## ***Interactive comment on “Impact of LUCC on Streamflow using the SWAT Model over the Wei River Basin on the Loess Plateau of China” by Hong Wang and Fubao Sun***

To: Hydrology and Earth System Sciences (HESS) Subject: Revise the manuscript (#hess-2016-332) The Authors: Wang & Sun The Title: Impact of LUCC on Streamflow Based on the SWAT Model over the Wei River Basin on the Loess Plateau of China Response: The authors appreciate Dr. Lacombe for helpful criticism and 8-pages constructive comments that improved our original manuscript. We have addressed the comments below and have made corrections. The changes being made are marked in red in the manuscript. Response to the main comments: 1: First of all, I am questioning the significance of the hydrological changes that actually occurred in the catchment over the studied period. Although figure 1 indicates that forested areas increased by

Fig. 1 The development of soil and water conservation measures in the main stream basin of Wei River over last 50 years.

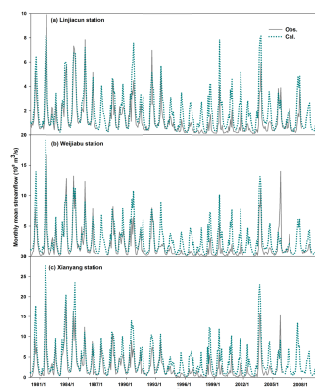
Fig.6 The time-series of precipitation, annual streamflow and runoff coefficients for the study area (3) There is an overall lack of clarity in the writing. The methods used should be explained in more details and with more precision. Figure 1 shows 4 types of treatments for water and soil conservation that occurred in the study area: forestation, terraces, grass and dam. The hydrological impact assessment focuses exclusively on forestation while the 3 others are completely ignored in the analysis. They certainly have altered river flows too. How to account for their effect in the SWAT model? The maps of the study area (figures 2 and 3) do not show where these technics have been implemented. Splitting the section "Results and discussion" into two distinctive sections "Results" and "Discussion" would certainly help the authors clarifying their scientific demonstration. As it stands, in many places, actual results are juxtaposed with results of previous research which are not referenced. Thank you for your criticism. We have revised the manuscript carefully and add more details to make the writing clarify and avoid possible grammar or syntax error. There were measures of foresta-

(Line 331-332). They were 3 control conditions when the land use converted from agricultural land to forest. The second and third conditions were considered as much as possible to reduce impacts of other factors. (32) Line 306: the authors indicate that the actual change in forest cover calculated using the land-use maps displayed in figure 3 (0.8% increase) would lead to less than 1% change in streamflow. I agree with this realistic statement but: is it consistent with the hydrological change quantified in line 270? Thank you for your suggestion. Line 306 is the result of conversion of agricultural land to forest on streamflow. Line 270 is the result of LUCC changes on streamflow, which involves many types of land use conversion measures and is a balanced result among these measures. So the changes of streamflow, surface runoff, soil flow and baseflow between agricultural land and forest were singled out (Fig. 9 The changes of 30-year (1980-2009) averages of streamflow, surface runoff, soil flow and baseflow between agricultural land and forest.). We can see the impacts are consistent. (33) Lines 314-325. the authors explain differences in hydrological behaviour of the Loess Plateau and earth-rock mountain, based on other publications, but this paragraph is not linked to the result of the study. The authors need to evidence how these distinctive hydrological behaviours influence their results. Thank you for your suggestion. As suggested, we revised the whole manuscript carefully and add more details to make it clean. Figures (34) Fig. 1: Areas under different treatments are expressed in 104 hm<sup>2</sup> (i.e. squared hectometers?). This is an atypical unit which is different from the unit used for the study area in the text (104 km<sup>2</sup>). All areas should be provided in same unit to allow easier comparison. It would be clearer to provide the percentage area so that we anticipate the possible effect of the land treatment on the catchment hydrology. Thank you for your suggestion. Figure 1 is revised as suggestion.

tion, terrace, grass and dam for soil and water conservation. According to Fig.1, we could see the soil and water conservation measures were mainly implemented in the study area after the 1980s in study area. Hence we choose 1960-1969 and 1970-1979 for the model calibration and validation respectively. For period of 1980-2009, we just used their measured and long-term daily meteorological data in the study area to drive the validated model for the designed hydrological experiments. Measures of soil and water conservation are classified according to LUCC types, which are divided into six types and further 25 subtypes. And the six types included forest, pasture, cropland, water body, residential area and bare. For example, the terrace is treated as Agricultural land with different slope. The impacts of terrace and dam on streamflow are clear. But the impacts of vegetation on streamflow are controversial and complicated and results are different among different basins. We also analyzed the impact of grass on streamflow monthly. The result was similar with forest and its impact on stream was smaller than that. So the forest was selected to analyze in detail. Detailed comments: (1) The title should be improved. Currently, it says that LUCC is impacted by the SWAT model. We changed the title to be "Impact of LUCC on Streamflow Based on the SWAT Model over the Wei River Basin on the Loess Plateau of China" (2) Abstract: in line 29, it is mentioned that SWAT is applied to the upper and middle reach of the Wei River Basin. It is not clear what is the role of the hydrological station at the outlet of the lower reach. Thank you for your suggestion. The Linjiacun, Weijiabu and Xianyang hydrological stations are used in our study (Fig. 2). Linjiacun station locates at the control section of the upstream and Xianyang station is the control station of middle reaches (line 135-136). And Weijiabu station locates between them. The hydrological stations of downstream or the outlet of Wei River were not in our study area. Three regions of different colors in Fig. 2 are divided by 3 hydrological stations of upper and middle reaches. (3) Introduction: Line 46: a/ the location of the Grain for Green project is missing. b/ Which trees are used for the reforestation? This information is important because, depending on the trees (e.g. deciduous or not), their effect on seasonal flow may be different. c/ the mode of forestation is also primordial when
